LAND OFF WEST MOOR CROFT ROAD, GOLDTHORPE (PHASE 3)

**Additional Supplementary Ecological Information (SEI)
including Revised Biodiversity Net Gain (BNG) assessment of
land within New Park Springs**

Prepared for Gleeson Homes Limited

SLR Ref: 424.03044.00237
Version No: 1
September 2022

PROPOSED ECOLOGICAL
ENHANCEMENTS
TO 'NEW PARK SPRINGS'

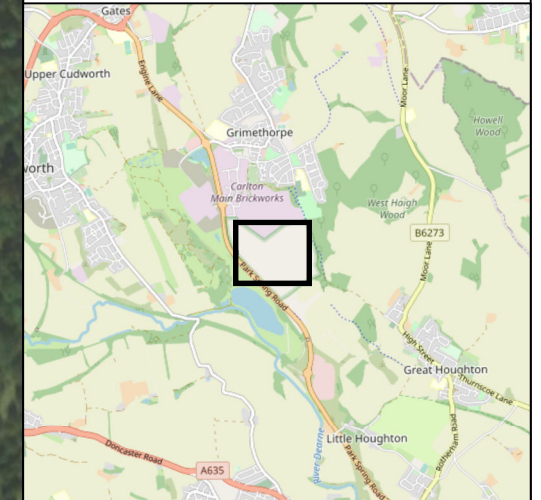
- The landscape proposals (Detailed Landscape Proposal (2 of 2) drawing no. 3627/3) show retained hedgerows on site. The metric sets out that all lengths of hedgerow will be retained on site; however, the landscape proposals appear to show a section of hedgerow to the north-western corner of the site to be removed. This should be confirmed and if proposed for removal, the metric should be amended accordingly.

As stated by Ms Lawrence, a section of hedgerow in the north-western corner of the Site is shown within the Landscape drawings as being removed⁴. The total length of hedgerow to be removed here is approximately 45 metres, and the Metric 3.1 assessment has been adjusted to reflect this (see entry for Hedgerow H4).

Following comments from Ms Katie Lawrence to increase the size of the orchid receptor sites, these have been enlarged slightly from that described in the earlier report, where deemed feasible, as summarised below:

By increasing the size of Orchid Receptor Areas 1-3, and maintaining Orchid Receptor Area 4 as it was originally, 0.786ha of grassland shall be enhanced within New Park Springs, this being larger than the 0.75ha of 'other neutral grassland' due to be lost within the application site itself.

This will require the removal of 1.25ha of coniferous woodland, in two blocks, rather than the 0.75ha earmarked for removal in the previous metric calculation. The mixed scrub shall comprise hawthorn (*Crataegus monogyna*), blackthorn (*Prunus spinosa*), dog rose (*Rosa canina*), hazel (*Corylus avellana*), guelder rose (*Viburnum opulus*) and elder (*Sambucus nigra*), along with pedunculate oak (*Quercus robur*), which shall comprise 10% of the overall mix. Planting shall take place at 3m centres, but there will be some variation of this, to create more naturalistic conditions.

All of these enhancements/ area of habitat creation are illustrated in Drawing 1.
